Moorebank Precinct West - Concept Modification

Supplementary Response to Submissions -
SSD 5066 MOD1

Author	Ben Fethers, Stuart Hill	 
Checker	Todd Brookes	
Approver	Westley Owers	
Report No	AA008765 - 01	
Date	4/08/2017	
Revision Text	Final

Figure 4-1: Targeted flora survey results 2017

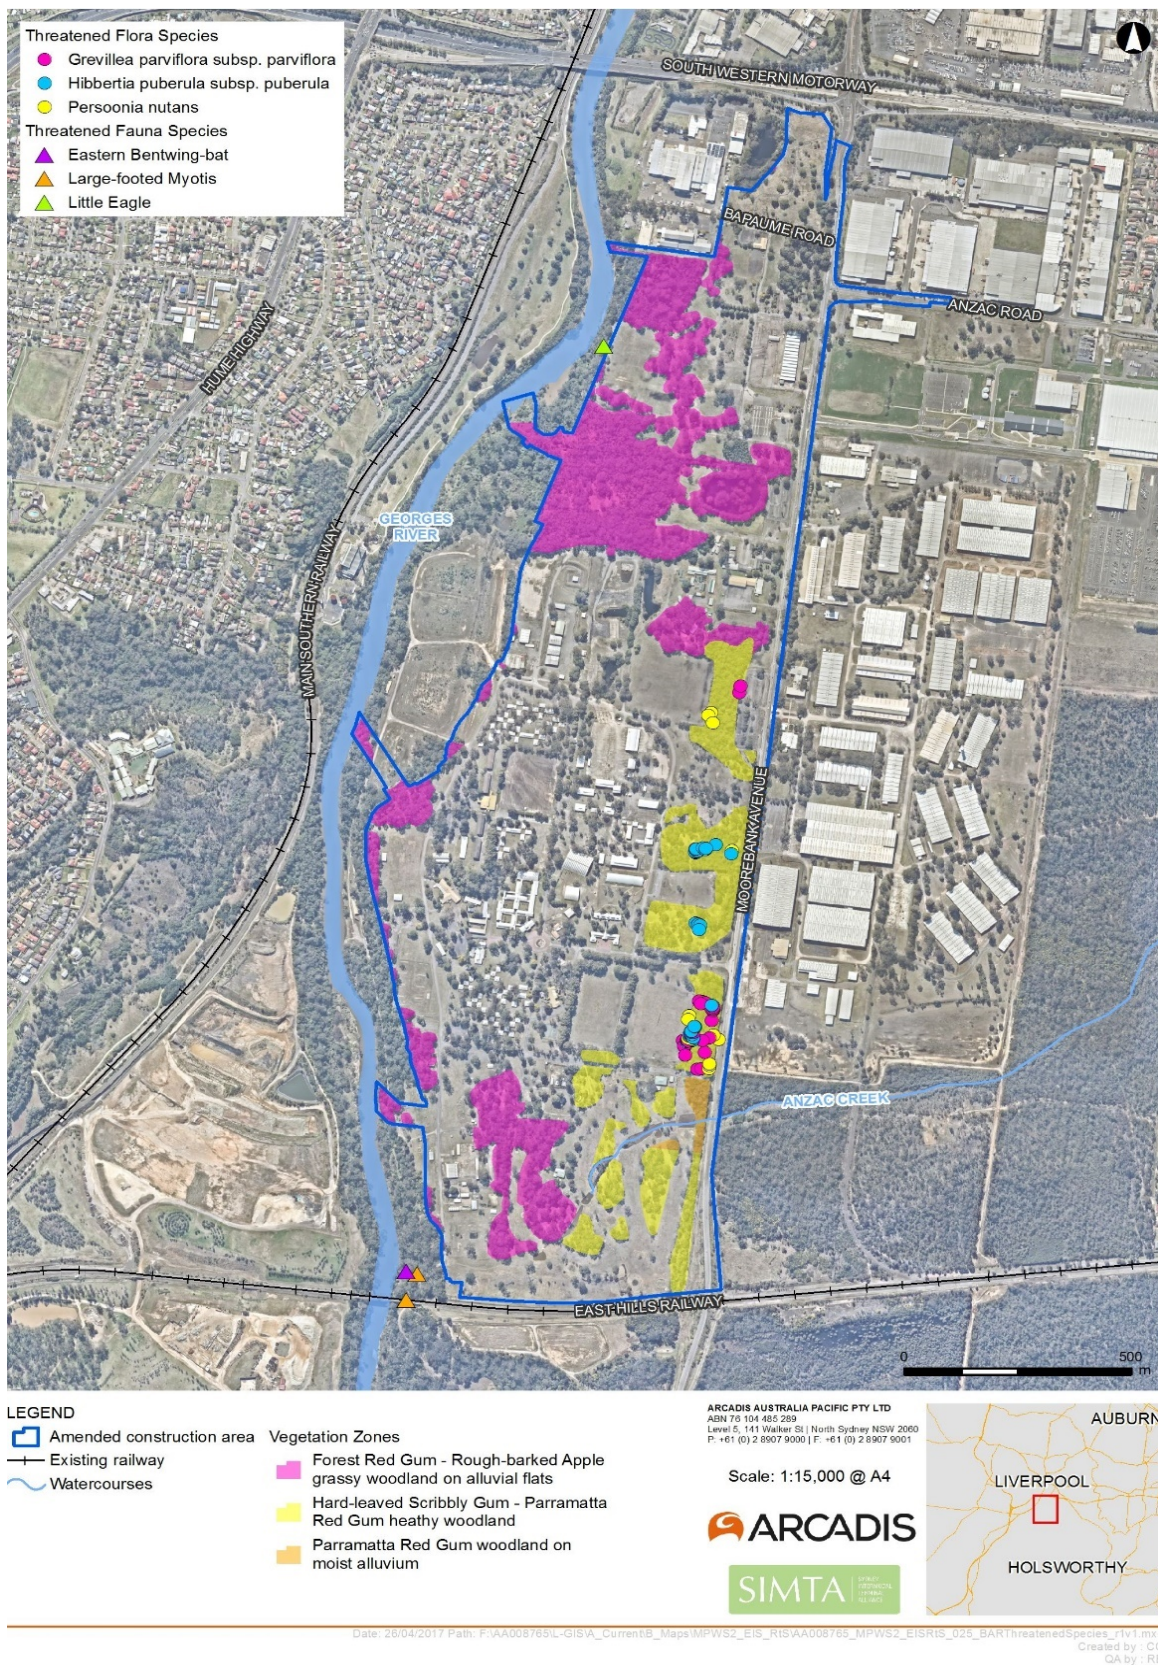
- **Targeted flora surveys:** In their submission, OEH recommended additional targeted flora surveys should be undertaken within 'priority area 2' of the MPW site given the threatened species found during recent surveys of the adjoining boot land south of Anzac Creek (e.g. *Hibbertia puberula* and *Hibbertia fumana*). These surveys should be undertaken if the importation of fill results in the clearing of any vegetation even if the clearing is permitted by the existing concept plan approval.

and 14 March 2017. Targeted searches for threatened plant species within areas of suitable habitat were conducted following the discovery of *Hibbertia puberula* subsp. *puberula* (listed as Endangered under the TSC Act) and *Hibbertia fumana* (a species previously presumed to be extinct, and now provisionally listed as critically endangered under the TSC Act) on the Boot land east of Moorebank Avenue in late 2016. Potential habitat for *Hibbertia puberula* subsp. *puberula* was identified on the MPW site, which includes Amended Modification Proposal footprint. Potential habitat for *Hibbertia fumana* does not appear to be present on the MPW site, but the species is associated with Hard-leaved Scribbly Gum – Parramatta Red Gum heathy woodland of the Cumberland Plain (OEH 2017), which is mapped on the MPW site. In accordance with the precautionary principle, targeted searches for threatened plant species included both species of *Hibbertia*.

The 2017 targeted surveys identified a population of *Hibbertia puberula* subsp. *puberula* in the east of the MPW site (refer to Figure 4-1). The other threatened plant species on the development site, *Persoonia nutans*, *Acacia bynoeana* and *Grevillea parviflora* subsp. *parviflora*, were also targeted and recounted. *Grevillea parviflora* subsp. *parviflora* was surveyed using stem counts instead of counts of individuals, to maintain consistency with surveys undertaken on the proposed biodiversity offset site.

The 2017 targeted survey recorded 333 stems of *Grevillea parviflora* subsp. *parviflora* and 16 *Persoonia nutans* in approximately the same locations as presented in the ecological assessments for the MPW Concept EIS (PB, 2014) and MPW Concept RtS (PB, 2015). *Hibbertia puberula* subsp. *puberula* was recorded in two of the larger patches of Hard-leaved Scribbly Gum - Parramatta Red Gum heathy woodland in the central eastern parts of the MPW site, however, these additional threatened species is located on land which has been previously approved and any potential impacts to these individuals is not related to the Amended Modification Proposal.
